**Subject:** RE: Grenfell - Fire Strategy comments

Subject: Grenfell - Fire Strategy comments

### 1. Separating wall

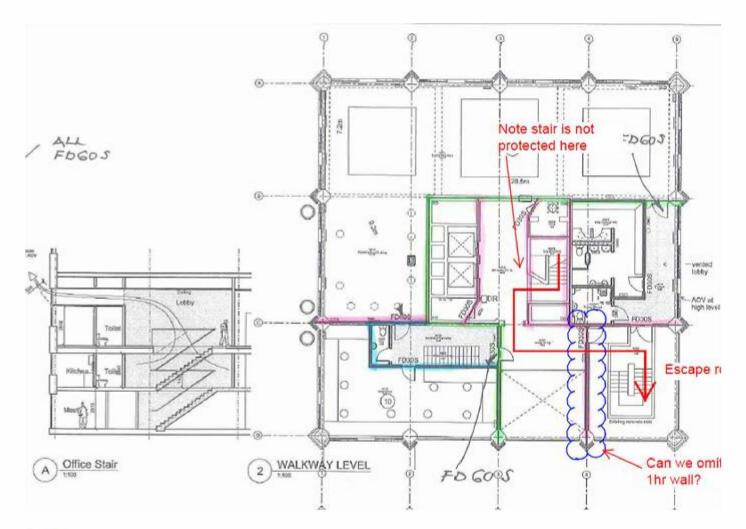
We don't like the separating wall between stair and lobby. There is a need to maintain a separation for security but it would be preferable if this was just a low screen and door at each level. The concierge would have a good view of what's going on.

I don't understand the need for the 60 minute separation because you have to pass though the (sterile) entrance lobby to get to the stair anyway. If there is a issue of smoke we could put an AOV on the façade.

I've re-done the compartmentation drawings showing what would be necessary if you didn't want to fire rate the screen and door between the boxing club stair and the entrance void. If you're happy with the changes, I'll amend the report and send it to you. The basis for connecting both AOVs to the stair is that the lower one will provide replacement air for the one at high level. There would be no need to have two AOVs at ground floor level unless you thought that was better architecturally. The opening between the stair and the shaft connecting to the AOV on the external façade could just be a louvred panel providing the same geometric free area as the AOV.

# 2. AOV

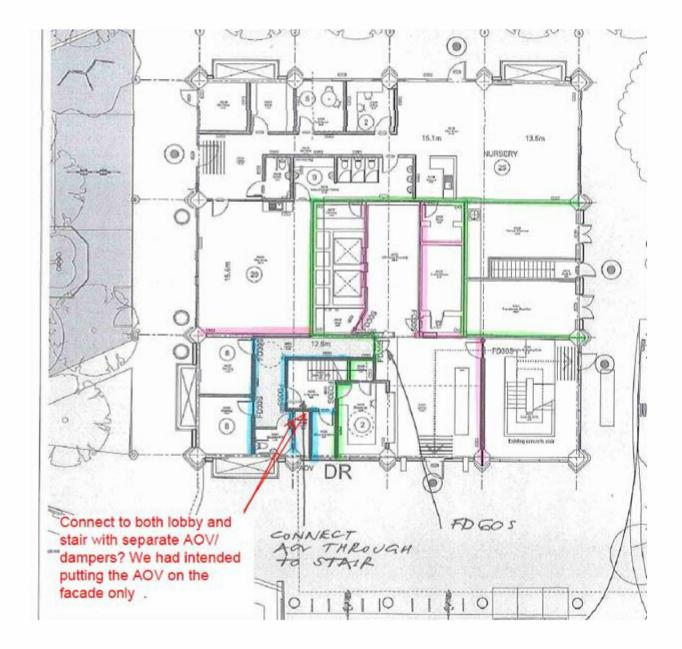
Please clarify how the AOV would operate? Would there have to be two internal AOV's and would they be fire rated and activated separately?
